Stage 06: Draft CUSC Modification Report

Connection and Use of System Code
(CUSC)

CMP237 'Response Energy Payment for Low Fuel Cost Generation'

| 06 | Draft CUSC Modification Report |

Figure 1 - Wind holding price for Primary frequency response

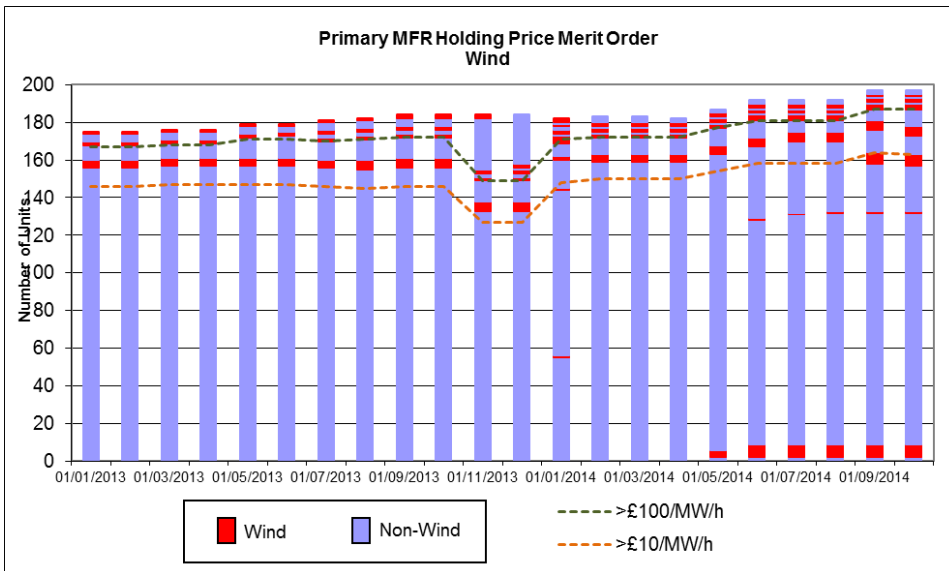
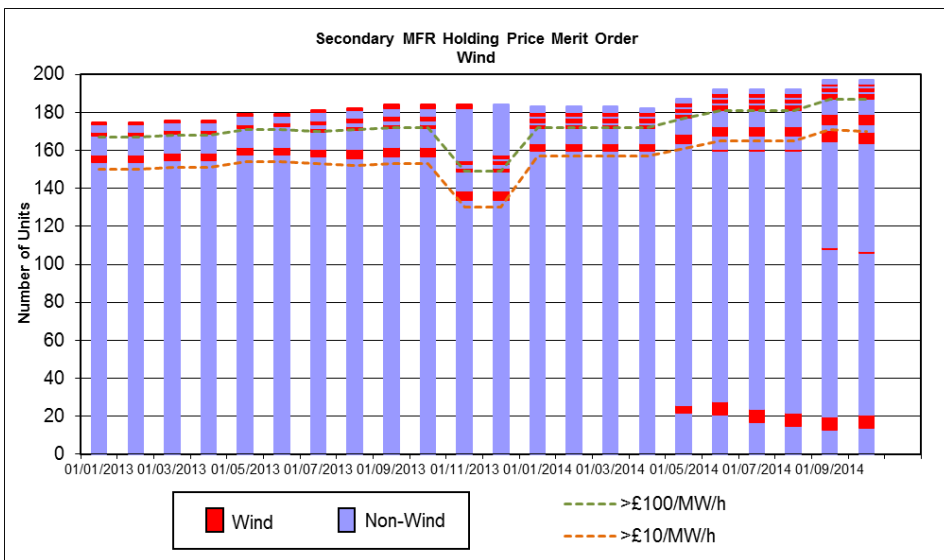
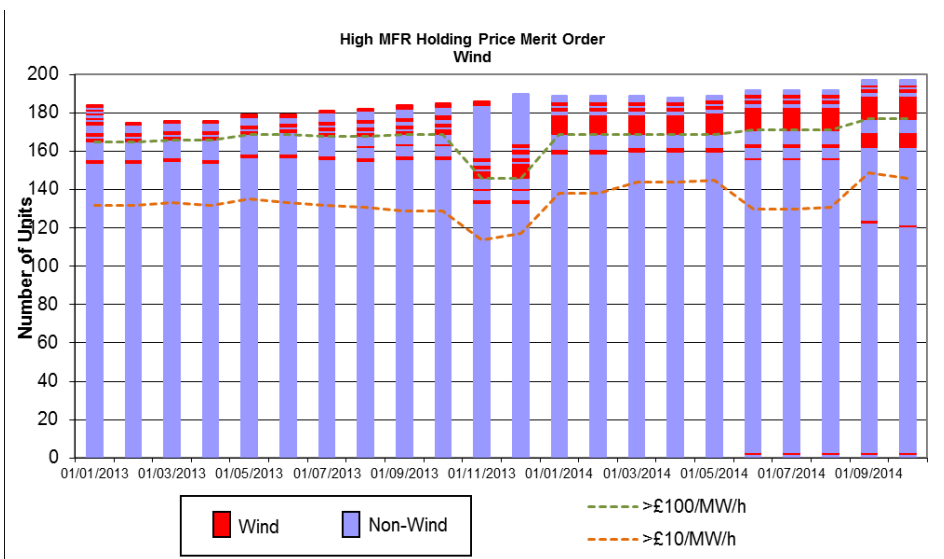
- 4.10 The Proposer presented three graphs which showed that the majority of plant providing primary, secondary and high frequency response are pricing themselves at less than £10/MWh. However, a proportion of these are submitting prices higher than £10/MWh and even higher than £100/MWh, the majority of which were identified as being wind plant. One Workgroup member noted that although there is a large amount of wind generation pricing themselves high, there are other (non wind) generation types providing prices as high as wind. These graphs can be seen in figures 1, 2 and 3.

- 4.11 One Workgroup member noted that on all three graphs presented, there is an anomaly in winter 2013 where a larger proportion of plant submitted prices higher than £100/MWh and asked if there was any reason for this. The Proposer noted that after investigation, no clear reason could be found for the behaviour as the plants involved were CCGT and coal from several different companies in different parts of the country. This is the first year that the behaviour has been exhibited, and therefore it is suspected that the values may have been default inputs into the FRPS system.

Figure 4 - submitted holding prices per generator against the estimated BM cost to move the generator to the assumed most responsive point for the 30th September 2014

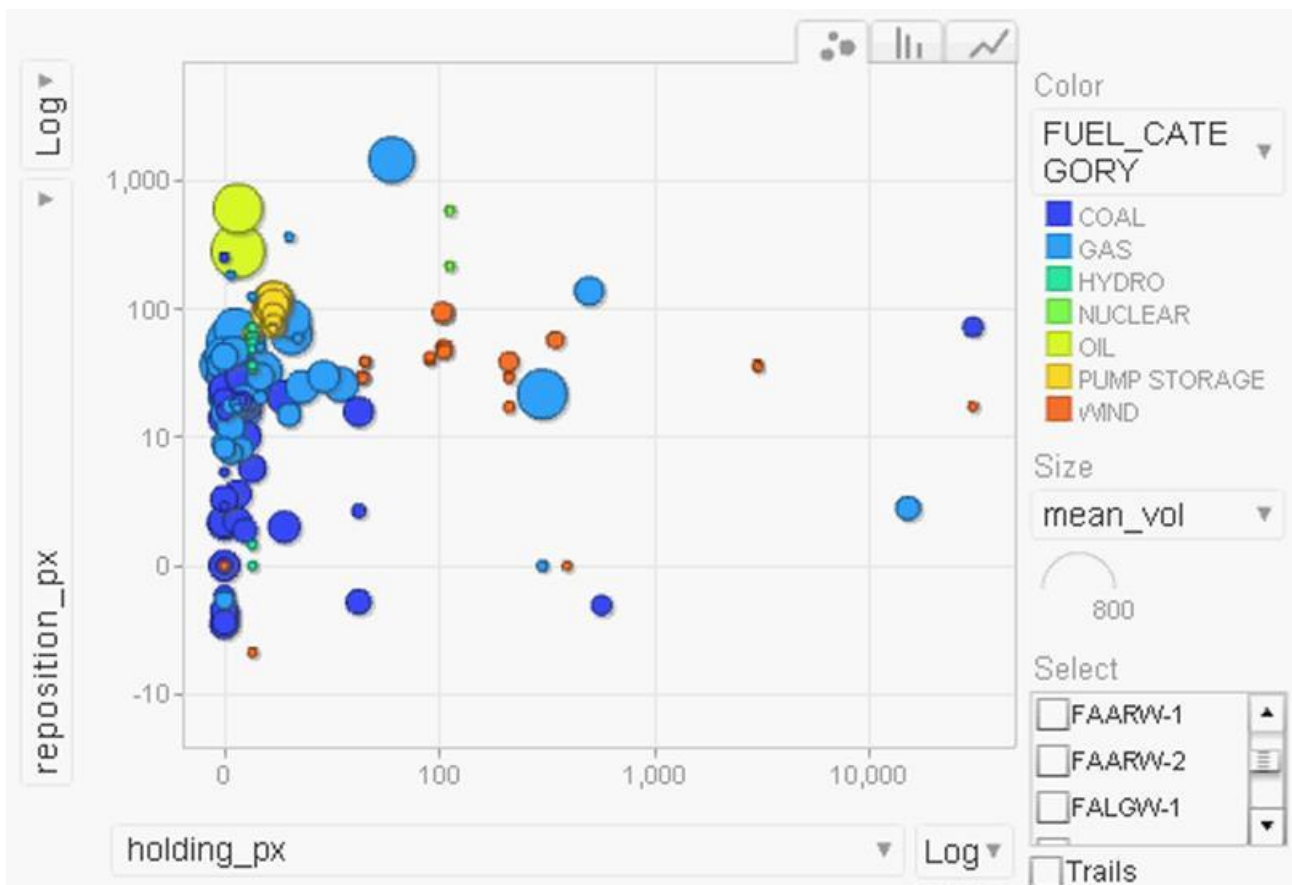
- 4.12 The Proposer also presented a graph (Figure 4 below) which illustrated the submitted holding prices per generator against the estimated BM cost to move the generator to the assumed most responsive point for the 30th September 2014. The size of the bubbles on the graph represents the available response. This graph can be seen below. The proposer noted that the graph was a snapshot, and the data for the whole year had been created as a video. The Workgroup agreed that this should be available alongside the Workgroup Consultation. If you wish to receive this video, please request this from the Code Administrator (contact details on page 2 of this report).

- 4.13 The proposer noted that the graph was intended to illustrate the total costs associated with instructing wind for response, as they typically have to be bid down in the BM before being instructed to provide response. For consistency, estimated BOA prices have been included for non-wind generation, however care should be taken in comparing wind with non-wind in the chart as instructing non-wind generation does not typically require an associated BOA.

- 4.14 A Workgroup member suggested that it would be useful to see the difference between high and low wind speeds and how this affects the BOA prices. After investigation it was identified that this would be a significant piece of work as it would require locational wind speed and historical BOA data to be combined per wind farm per settlement period. Whilst

- 4.15 One Workgroup member noted that on fig 4 above, the general trend for generation with a fuel cost tended to follow the Y axis, whereas those without a fuel cost tended to follow the X axis. The Workgroup member stated that as hydro generation clearly following the Y axis like other conventional plant, this supported the view that they should be considered as having a fuel cost for the purpose of this Modification. It was noted, however, that there may be other reasons why a group of generators had similar holding prices; e.g. plant with similar construction may have similar sunk costs to recover, and that this was not direct evidence of the existence of a short-term fuel cost.

The competitive situation is most starkly shown in Figure 4 of the consultation document. This shows that hydro generation competes with other mandatory frequency response service providers (which are classified (artificially) for the purposes of CMP237 Original as ‘fuel cost’ such as coal, gas, nuclear, pump storage and oil) via the holding payment and REP. Figure 4 shows hydro generation clustering with the ‘fuel cost’ generation along the vertical. In stark contrast to this, wind generation can clearly be seen along the horizontal and no clustering pattern with ‘fuel cost’ generation can be easily discerned.

Figure 5 – Submitted holding prices per generator against the estimated BM cost – No fuel cost generators under Original proposal.

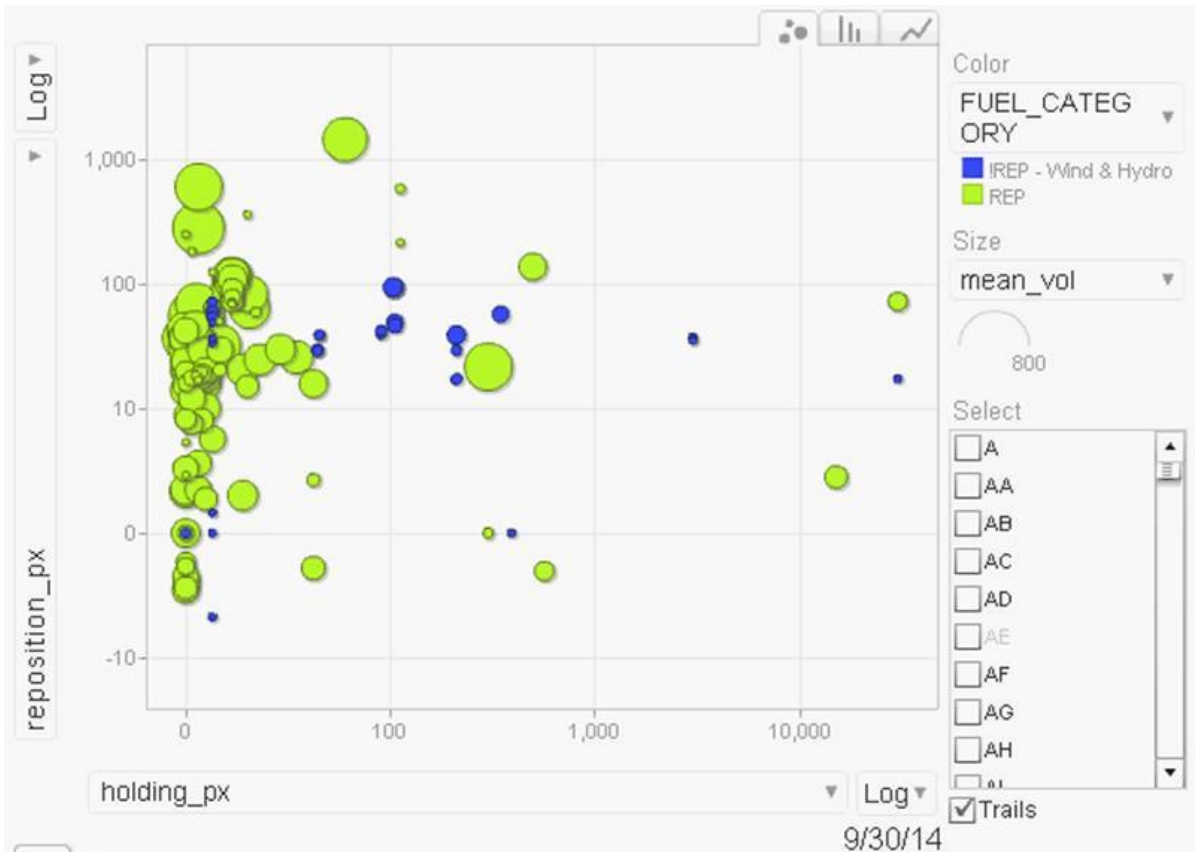
4.18 The chart of submitted holding prices per generator against the estimated BM cost was produced which highlights the No Fuel Cost generators as per the Original Proposal.
